**Bernard Drive Contract 1 Project Addendum #2**

**TO:** Prospective Respondents and Other Interested Parties  
**FROM:** The Village of Buffalo Grove Finance Department  
**ISSUE DATE:** November 8, 2023  
**SUBJECT:** ADDENDUM #2

The following changes and clarifications shall be made to the Bid Documents for the Bernard Drive Contract 1 Project.

NO.	DATE	NATURE OF REVISION	CHKD.	DGN.	VMR	TITLE:
2	11/07/23	ADDED TWO INLET FILTERS		DWN.	MAK	<b>BERNARD DRIVE EROSION CONTROL AND LANDSCAPING PLAN</b>
				CHKD.	LMF	
				USER NAME = nhowellindgren		
				PLOT DATE = 11/8/2023		SCALE: 1:20

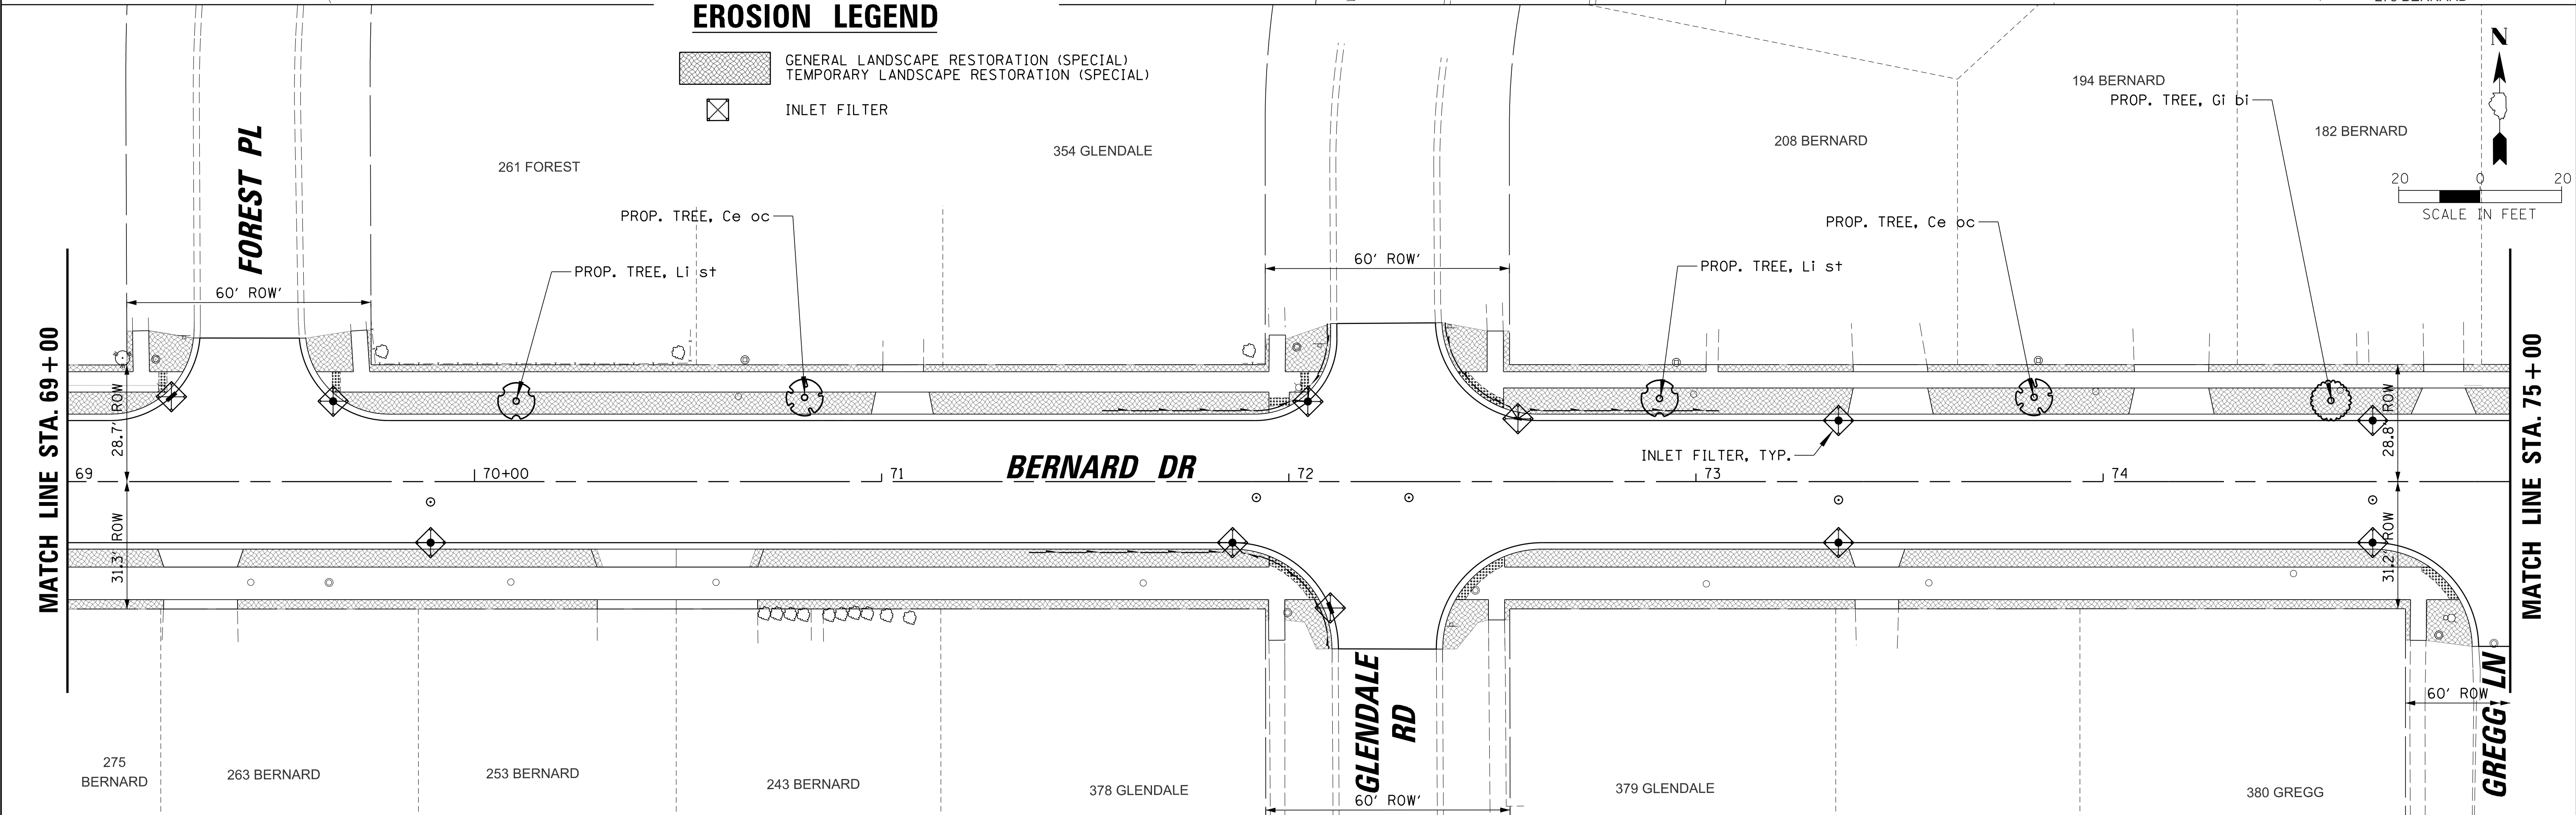
The quantity for INLET FILTERS (Item 7) has increased from 43 Each to 45 Each. A new pay item has been added for CATCH BASINS TO BE ADJUSTED (Item 40). The quantity for this work is 2 Each. This additional work is required because the limits of reconstruction on Melinda Lane have been extended north. Attached to this addendum are the following:
